**Ashburton Salt Project
Groundwater Modelling Independent Review
June 2021**

CyMod Systems was appointed to undertake an independent review of the numerical groundwater model, which was constructed and calibrated to assess the potential impacts of the proposed K+S Ashburton Salt Project on environmental receptors.

Figure 4-1: Soil Classification showing Relationship between Particle Size and Specific Yield (Johnson, 1968)

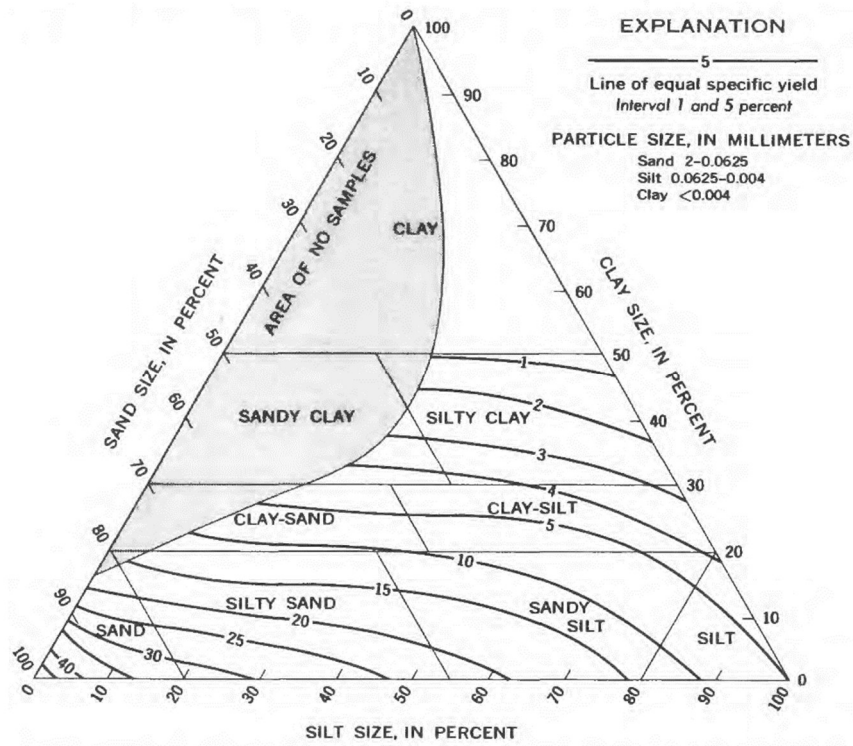
A brief review of estimates of specific yield from particle size distribution of field samples is shown in Table 4-2. Estimates of specific yield have been taken from Figure 4-1 based on silt/clay content measured in soil samples. The data suggests that a specific yield of 0.05 and an effective porosity of 0.10 as suggested in the conceptual model for the 1A/B formation are reasonable but conservative. The limited data for the 2A and 2B formations suggests a low specific yield may also be conservative.

The effective porosity of 0.10 as used in the 1A/B unit is consistent with conservative estimates of these properties, as indicated in the report. The low effective porosity will increase the impact of seepage and EVT, in terms of rate of change in salinity and groundwater level changes.

It is also noted that test pumping of BH7 TB, BH10 TB measured responses primarily in the 2A/B formation and indicated a specific yield of 0.05. It is likely the 1A/B formation will have higher specific yield, given higher sand content.

Figure 1: Mangrove Monitoring - Pilbara, 1990

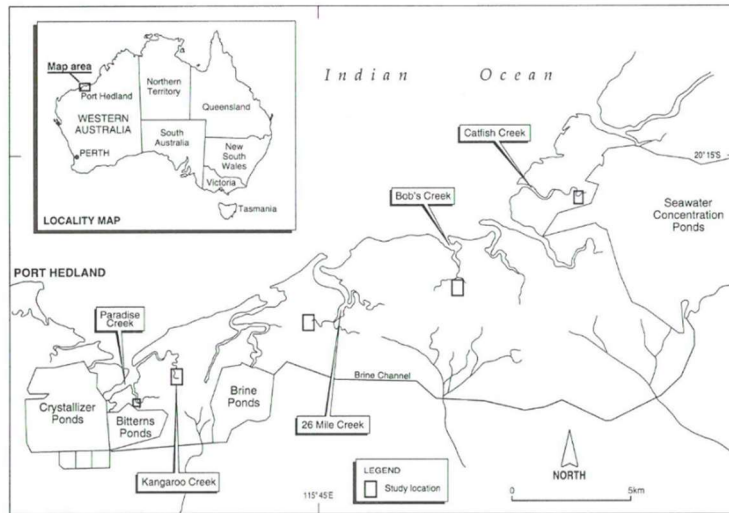
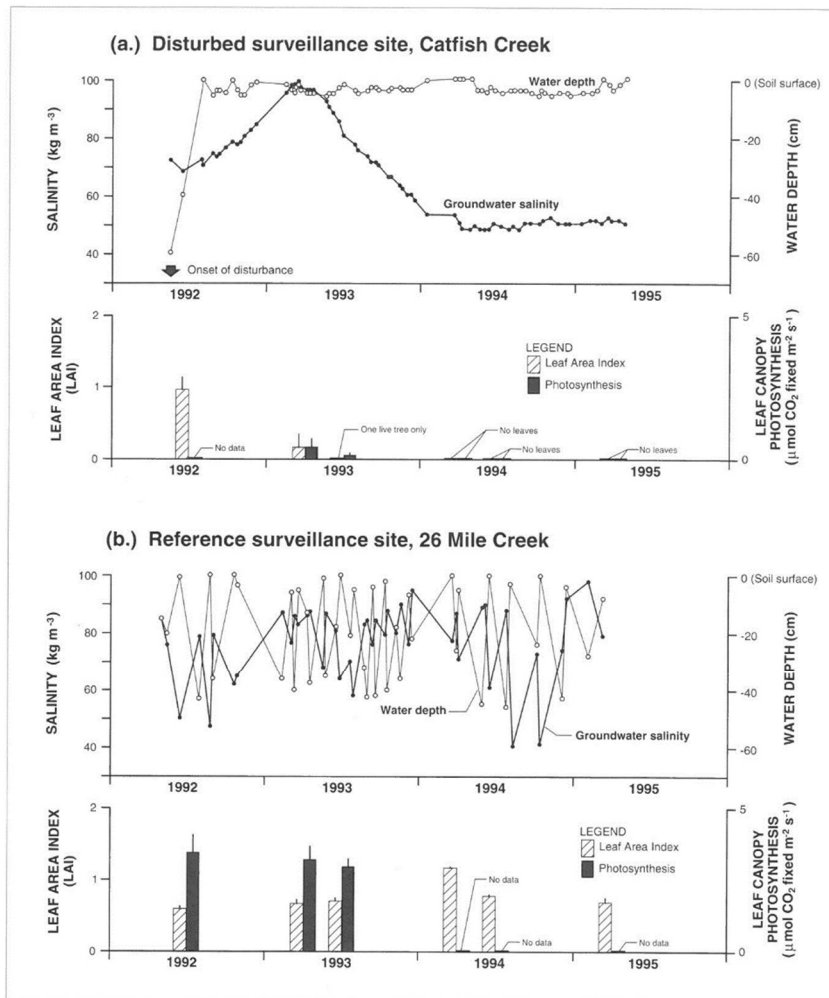
A secondary effect on pond seepage is also caused by the lack of vertical resolution in the model. The mixing of pond seepage into the relatively thick layer 1 of the model results in much less dilution than would occur in practice. In practice, pond water salinity in ponds 1, 2 and 3 is much less than that of shallow groundwater, and hence, any seepage will tend to float on top of the denser insitu brine. This light low-salinity seepage will migrate through pond embankments and to a lesser extent displace the in-situ dense brine downstream. The net effect is that shallow groundwater in the vicinity of the salt ponds is likely to have similar salinities to that of pond water floating on denser in-situ brine. This buoyance effect is only effectively modelled using sufficient vertical resolution (i.e., layers) to simulate the vertical salinity gradient in the vicinity of the salt ponds.

The above effects were measured at a site downstream of a salt pond in the Pilbara (Figure 1, Catfish Creek), as shown in Figure 2 (Gordon *et al*, 1995). Note that mangroves did not recover, even though groundwater salinity declined to viable levels, but water levels remained elevated due to pond leakage (essentially water logging of the mangroves). Such water logging may or may not be an issue for mangroves at the Ashburton Salt Site given the different physical location and distance from the ponds compared with the example provided. However, this requires further project specific investigation via revised modelling.
